SITE PLAN REVIEW

LOT NO. 11 REGISTERED PLAN 434-2057

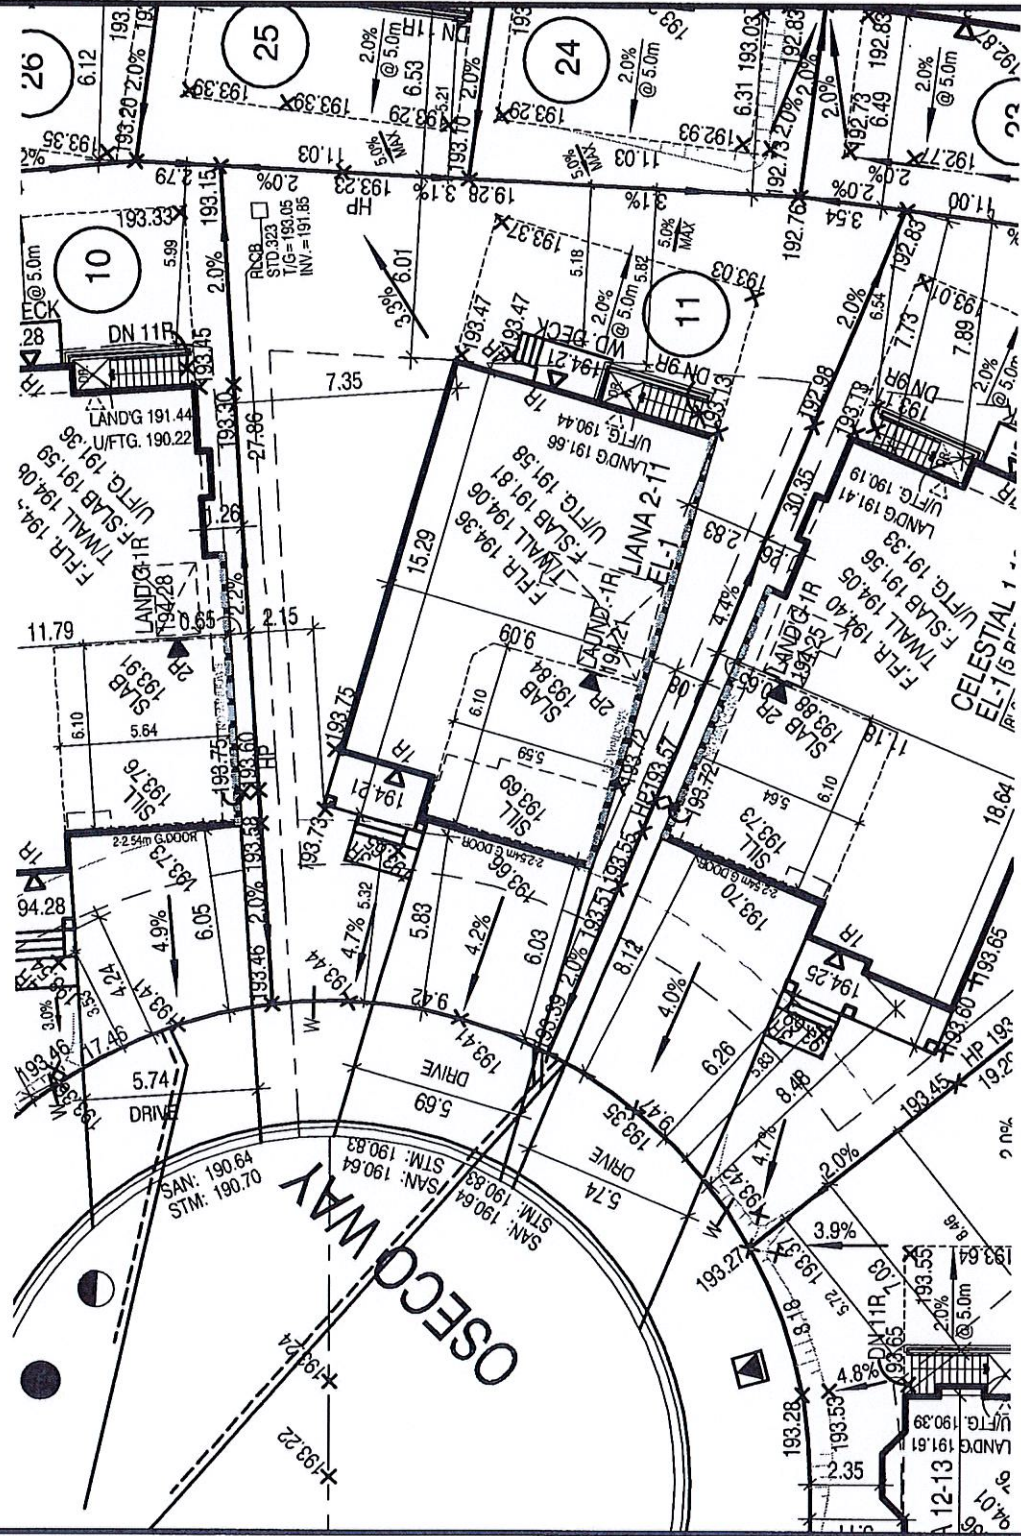
THE PROPOSED LOT GRADING AND DRAINAGE IS APPROVED AS BEING IN CONFORMITY WITH THE OVERALL APPROVED GRADING PLANS FOR THE SUBDIVISION
